ELECTRONICS FIELD CHANGE BULLETIN
NAVAL ELECTRONIC SYSTEMS COMMAND
WASHINGTON, D. C.

AN/FRT-39
AN/FRT-40
AN/FRT-62

PURPOSE: This modification provides remote on/off control of the transmitter carrier. In addition, the unit provides an indication of transmitter status by means of signals to a display board located at the transmitter monitor control console or elsewhere at the transmitter site. In order to accomplish this modification, Tone Intelligence Unit Model TIS-3 is physically replaced by Transmitter Keyer Monitor Control Unit. Tone Intelligence Unit TIS-3 will be relocated to the CCL facilities at the transmitter site or to some other remote location.

FIGURE 3

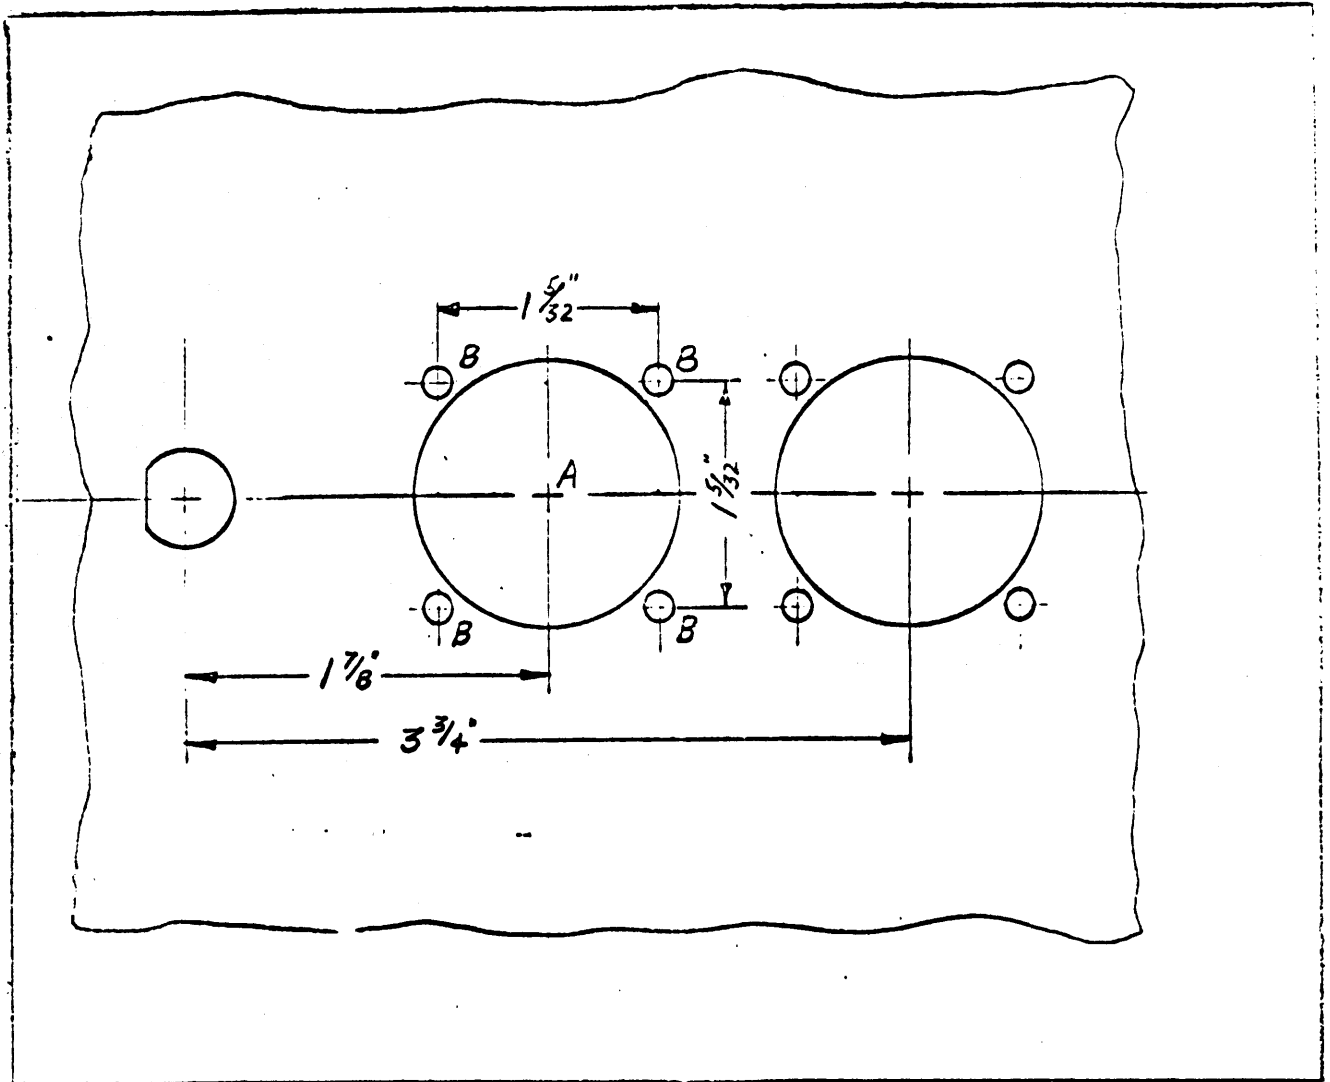
- (a) Mark MS-3679, using figure 3 for dimensions.
- (b) Using the 9/64" drill bit, 3/8" drill bit and the 1-5/16" chassis punch, modify MS-3679 as shown in figure 3.

A - $1\frac{5}{16}$ " DIA. 1 REQ.
B - $\frac{9}{16}$ " DIA. 4 REQ.

FIGURE 4

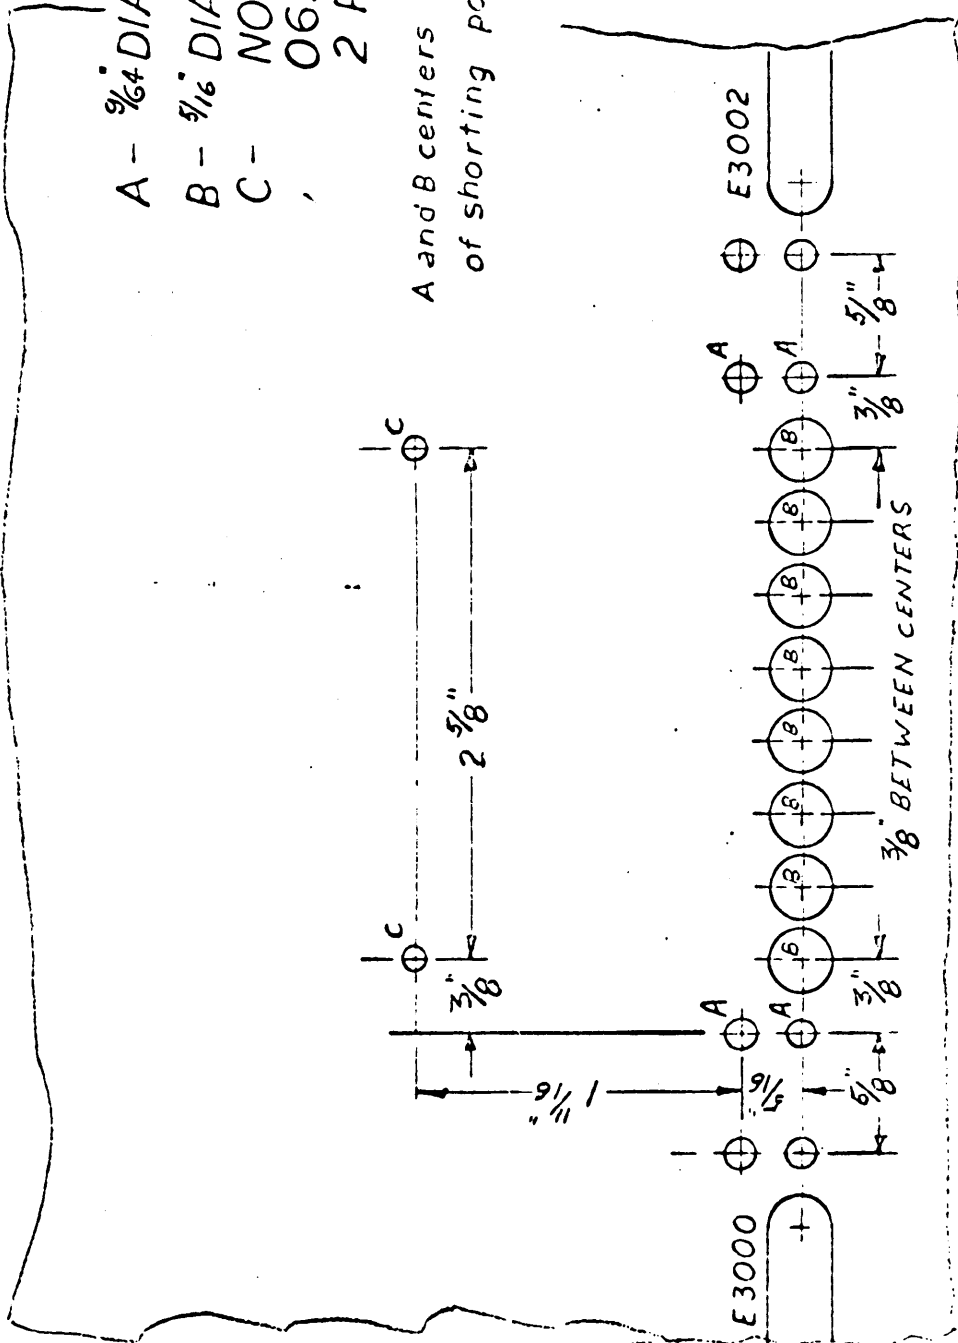
- (c) Mark MS-2469, using figure 4 for dimensions. Using the 9/64", 5/16" and the No. 36 drill bits and the 0632 UNC tap, modify MS-2469 as shown in figure 4. Using the terminal strip, insulation paper, 2 saddle plates, 4-5/8" 4-40 screws, 4 nuts, 2 lock washers and 2 ground lugs (item 32), mount the terminal strip identically as E3000 and E3002 position on the center shield. Remove J3002 from the center shield assembly. Replace with the new jack supplied (UG-492/U, item 29). Mount the UG-274/U "T" to the feed thru on the equipment side. Cut the removed J3002 (JJ-172) from the cable. Connect the PL-169 to this cable. Connect this PL-169 to the "T" on the equipment side of the center shield; solder the No. 16 buss wire to the ground lugs as is done on the other strips. Using the stamps provided, stamp the center shield as shown in figure 5. Refer to step 21 for stamping instructions. To seven lugs of the strip, running consecutively right to left from No. 14 of E3000, connect the 1000 mmfd capacitors. Connect the other end of the capacitors to the ground buss as is done on the other strips. To the eighth lug, connect a length of No. 22 buss wire to the ground buss. Position the connections on the terminal strip lugs to leave enough clearance to connect the cable in a following step.

A - $\frac{3}{64}$ " DIA. 4 REQ.

B - $\frac{5}{16}$ " DIA. 8 REQ.

C - NO. 36 BIT
0632 UNC TAP
2 REQ.

A and B centers critical because
of shorting possibility.

FIGURE 5

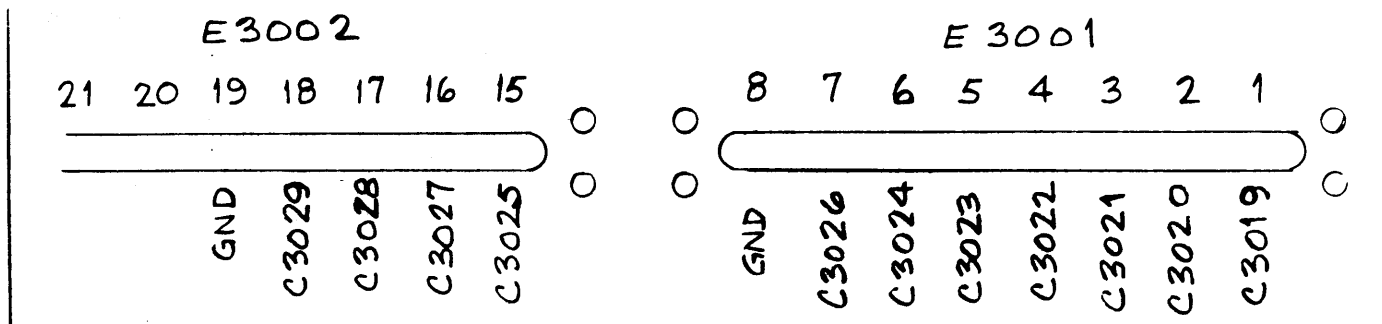
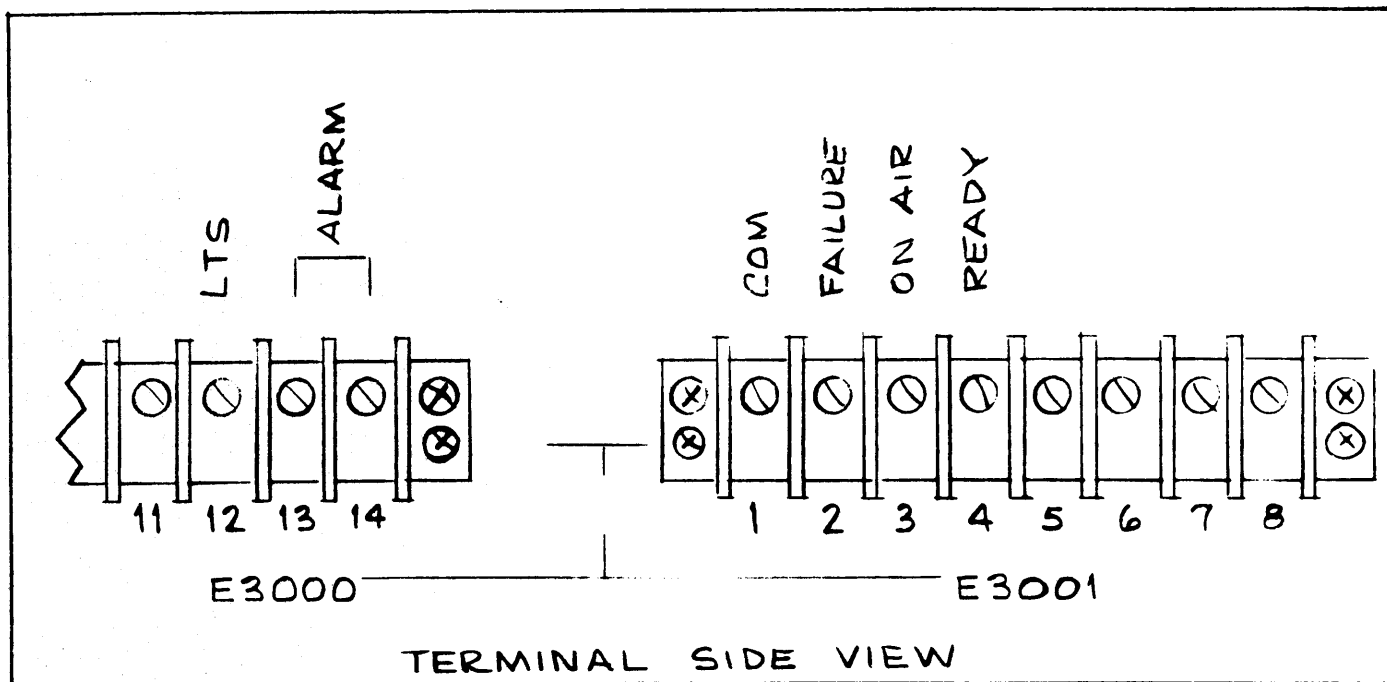
19. Remove markings on rear of center shield above terminals 12, 13 and 14 of E3000. Using items 12, 61 and 62, mark rear of center shield above terminals 12, 13 and 14 of E3000 as shown in figure 5.

FIGURE 6

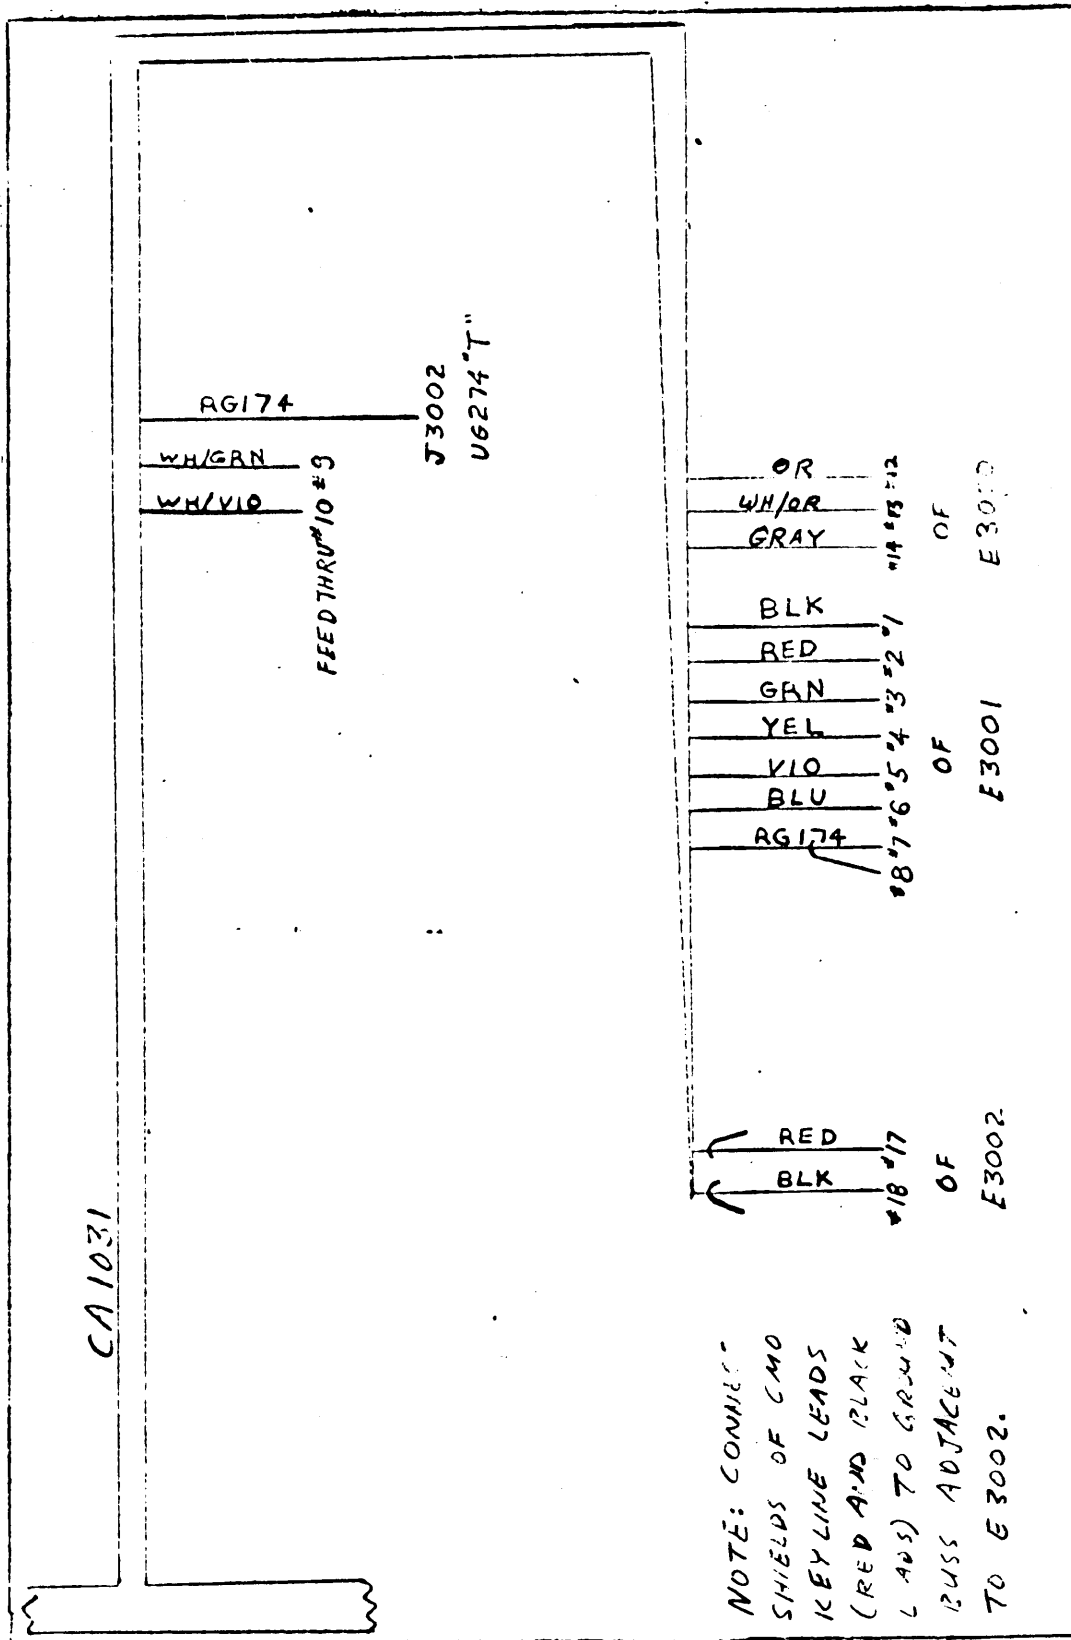
- (a) Align the center shield breakout of CA-1031 with the center shield breakout of the main cable. Lace the two center shield breakouts together. Connect and solder the leads as shown in figure 6. Along the main cable, lace the KMCU breakout to the cable as far as the TIS breakout. Do not lace the KMCU and TIS breakouts. Lace the CHG breakout along the main cable and the CHG original breakout. Leave enough slack at the plug to allow free movement during connection.

FIGURE 7

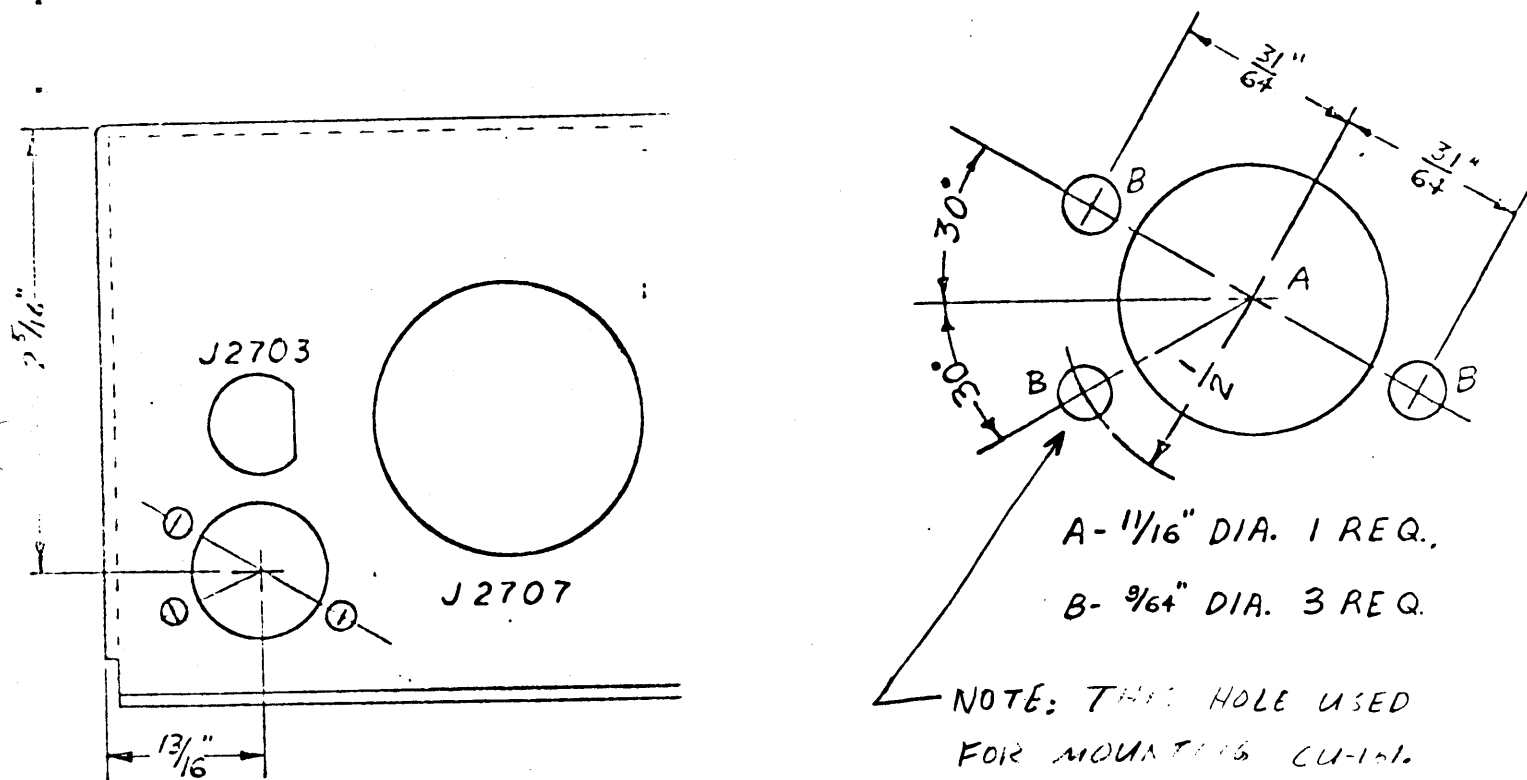
- (a) Remove dust covers from the CHG.
- (b) Mark the main chassis as shown in figure 7. Using the 9/64", 3/8" drill bits and the 11/16" punch, modify the chassis as shown in figure 7. Use extreme care during this portion as the internal wiring is in close proximity to the holes. Using the stamp provided, stamp J2708 on both sides of the chassis. Refer to step 24 for stamping instructions.
- (c) Using three 5/16" 4-40 screws, nuts and lockwashers, mount the JJ-119-2 of CA-1028 internally and CU161 externally. Route the cable along the main harness and lace. Connect the orange wire to the orange wire on C2773. Route and lace the white/orange wire under the tube and along the main harness to the B+ switch. Connect the white/orange wire to the junction of the switch and the coil L2101.
- (d) Replace the dust covers.

FIGURE 1

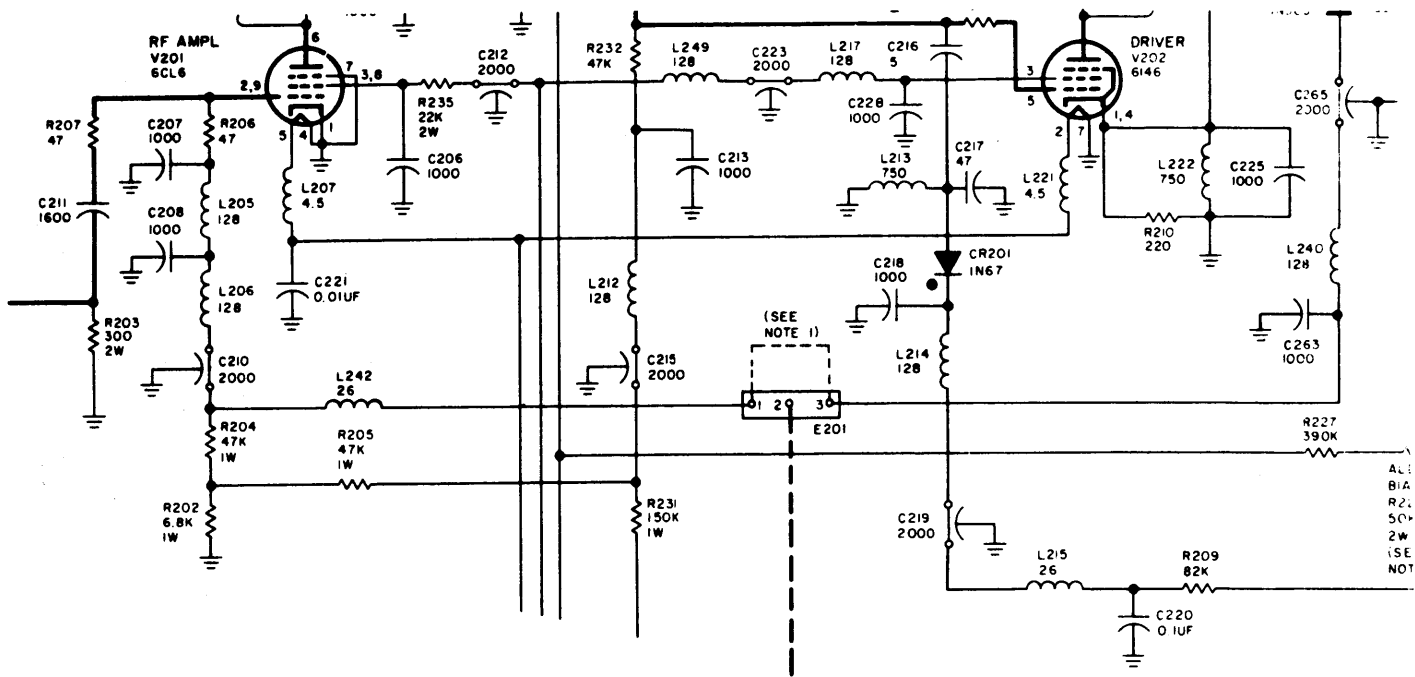
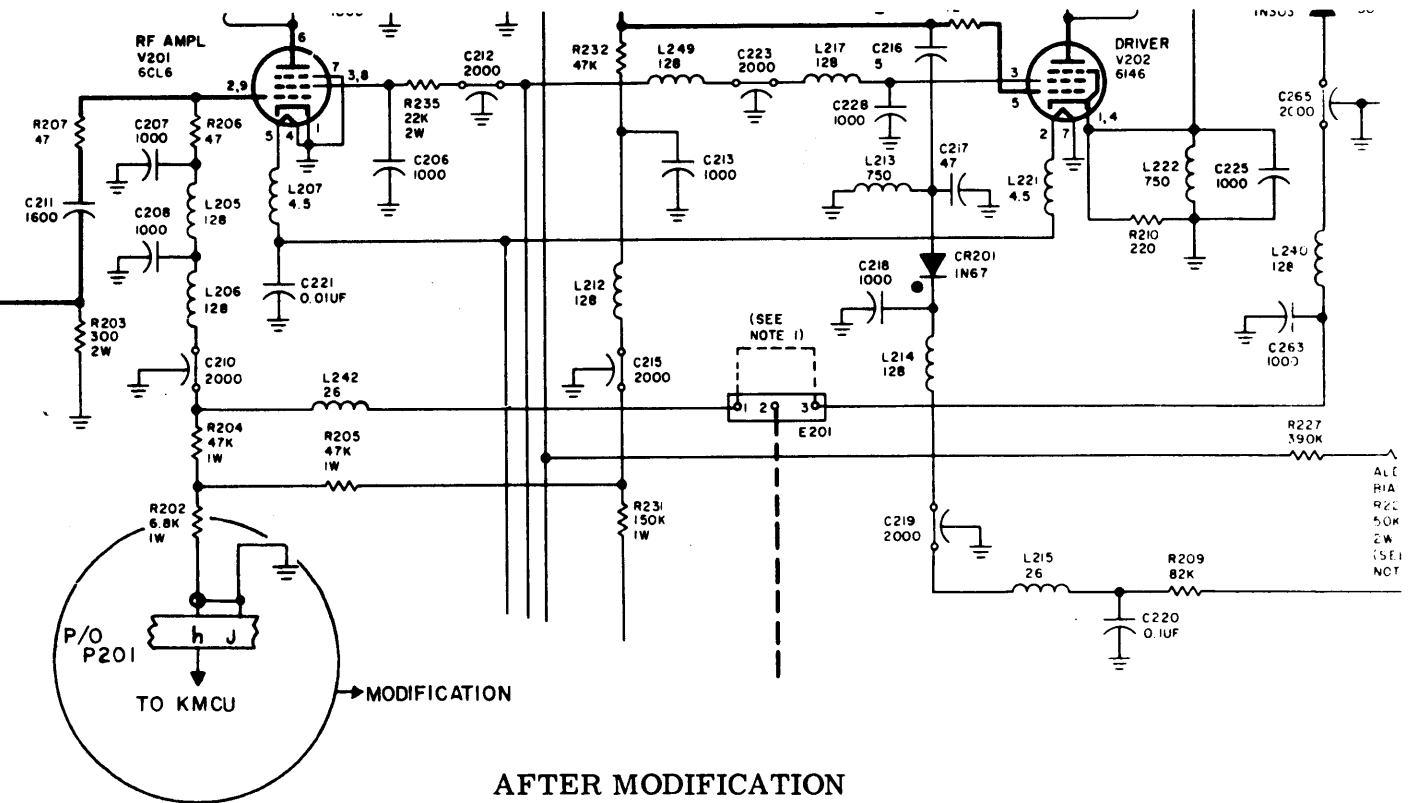
(b) SCHEMATIC DIAGRAMS (Section 6). - Schematic diagrams given in section 6 of the maintenance manual should be amended as shown in figures 1, 2, and 3.
